Service Bulletin

Bulletin No.: 08-06-03-006C

Subject: Engine Running with Key Off, Continuous Run – Sensing Diagnostic Module (SDM), No Communication, Service Air Bag Light Illuminated, DTCs B1440, P0381 or P0650 (Install Diode to Solenoid/Relay)

Models: 2007-2014 Chevrolet Silverado 2500-3500 Series
2007-2014 GMC Sierra 2500-3500 Series

2150773

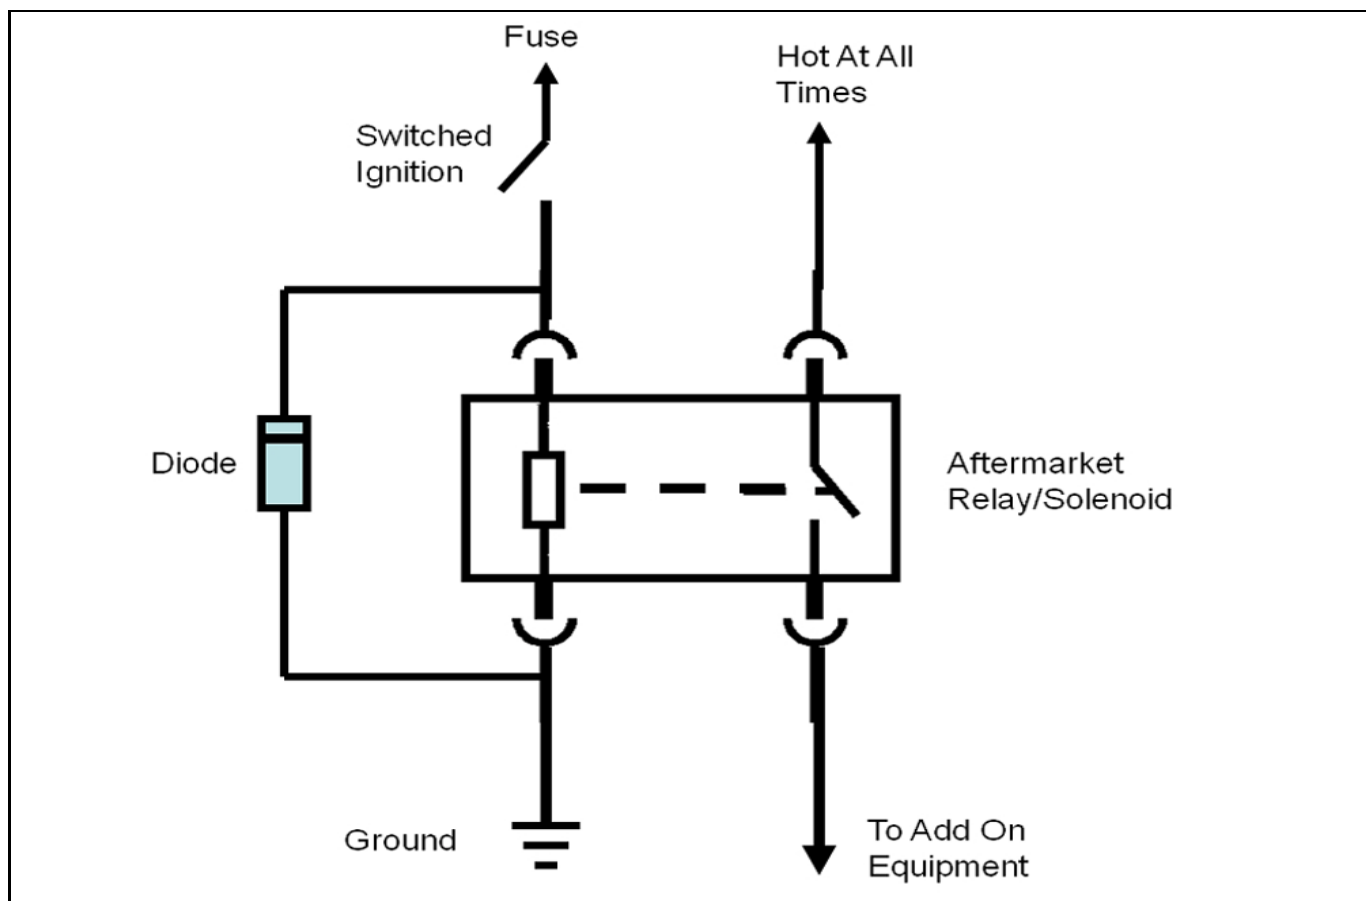
Install a diode, P/N♦12112422, across the coil of the solenoid. It is important that the striped end of the diode be connected to the positive terminal of the coil and the other end of the diode be connected to ground.

Important: Be sure to insulate the diode with heat shrink tubing before installing as shown in the picture above.
